STAFF RECOMMENDATION
706 Fatherland Street
August 19, 2020

Application: New Construction – Addition; Alterations
District: Edgefield Historic Preservation Zoning Overlay
Council District: 06
Base Zoning: R8
Map and Parcel Number: 08216024200
Applicant: Rob Cowles
Project Lead: Melissa Sajid, Melissa.sajid@nashville.gov

Description of Project: Application is to construct a rear addition and to retain front porch posts that were replaced without a preservation permit.

PROPOSED ADDITION

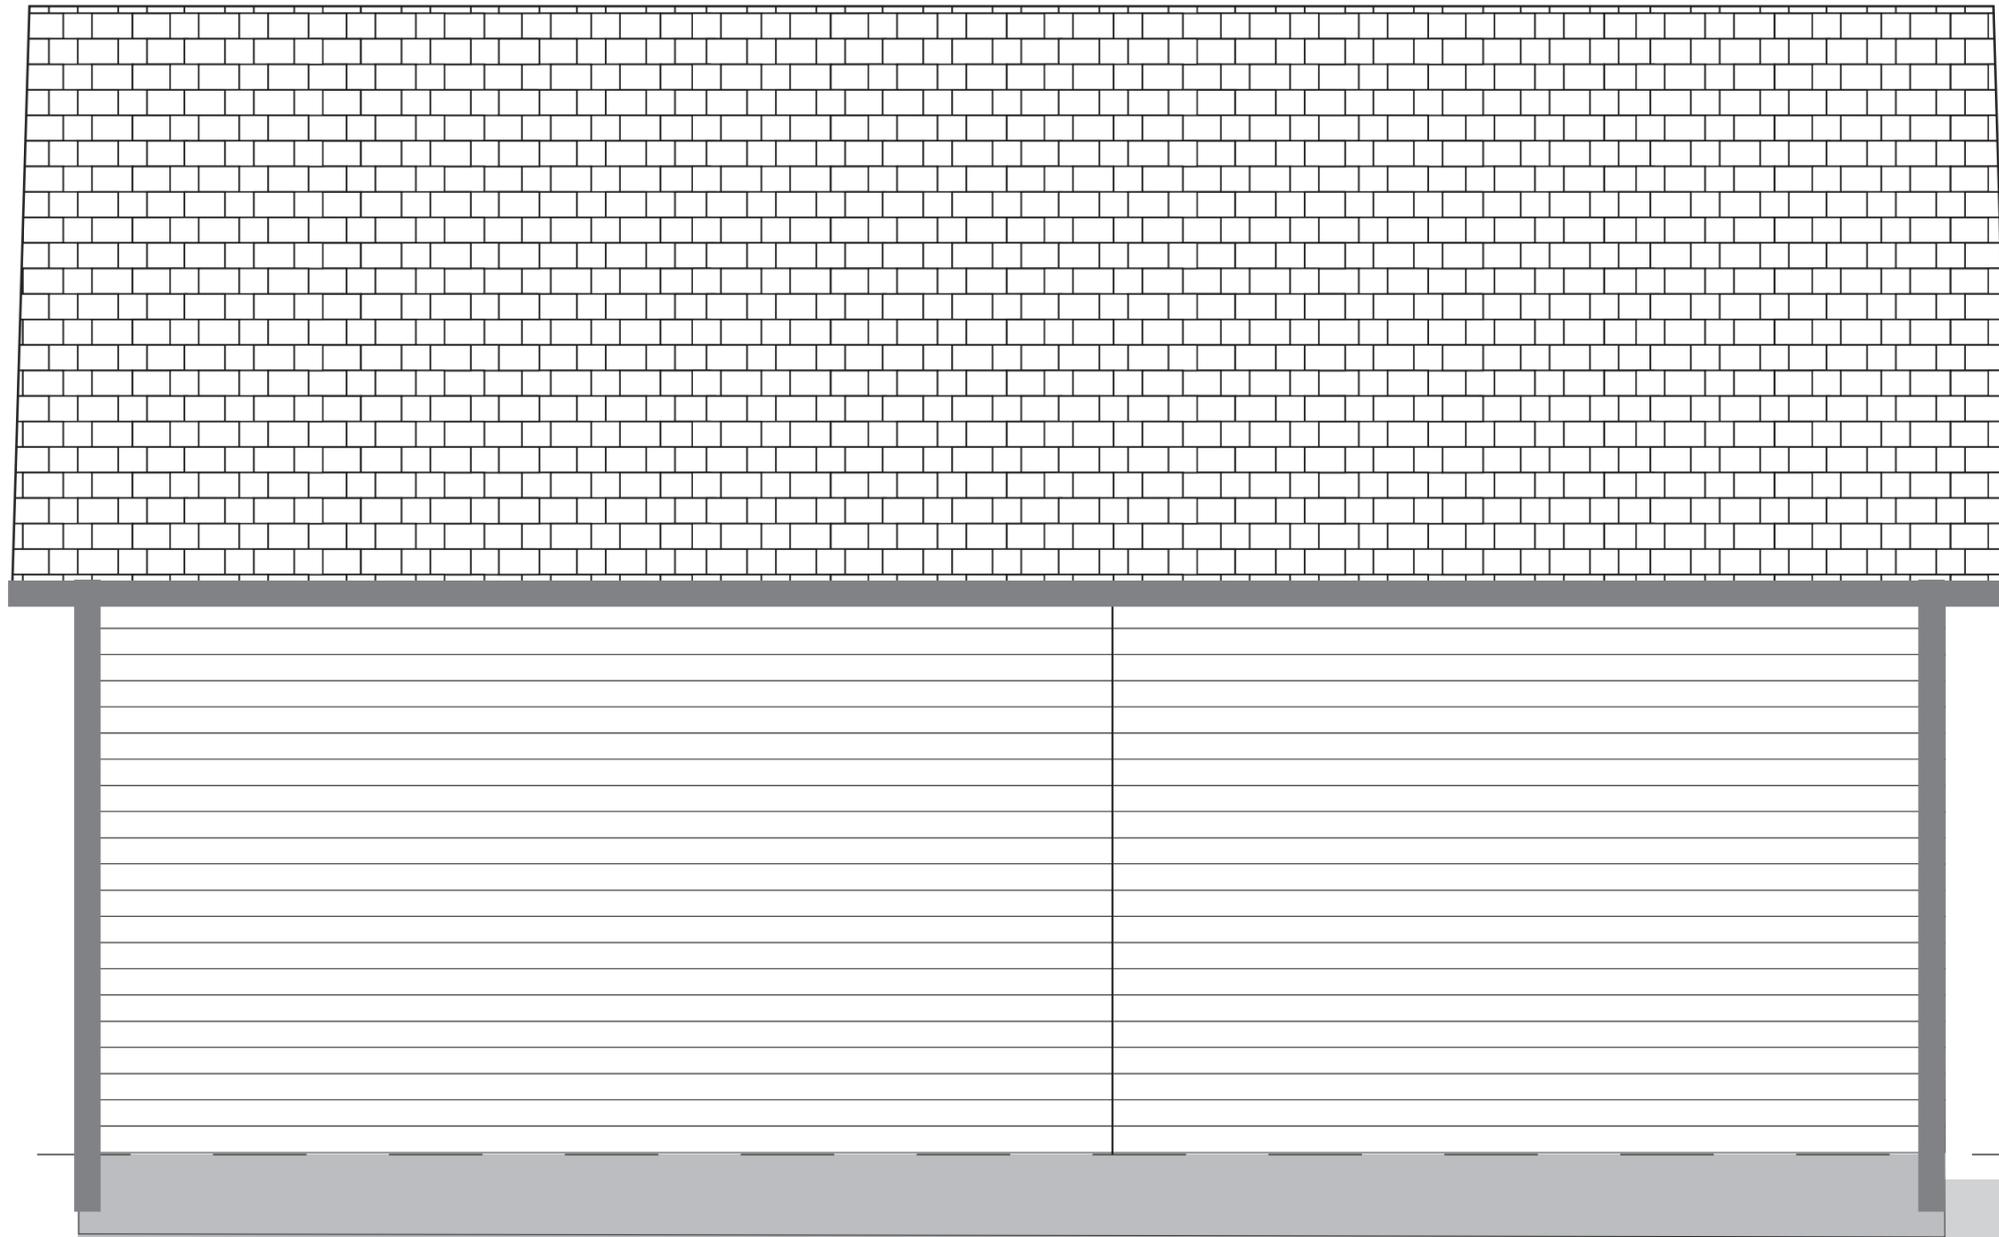
Height & Scale: The request is to add a single-story addition to a single-story historic house. As proposed, the addition is neither taller nor wider than the historic house and does not more than double the existing footprint. The addition adds a net footprint of approximately eight hundred eighty square feet (880 sq. ft.) to the existing footprint of approximately nine hundred eighty-six square feet (986 sq. ft.).

Setback & Rhythm of Spacing: The addition meets all base zoning setbacks. As proposed, the addition is located ten feet, six inches (10'-6") from the left-side property line, eleven feet, six inches (11'-6") from the right-side property line, and eighty feet (80') from the rear property line.
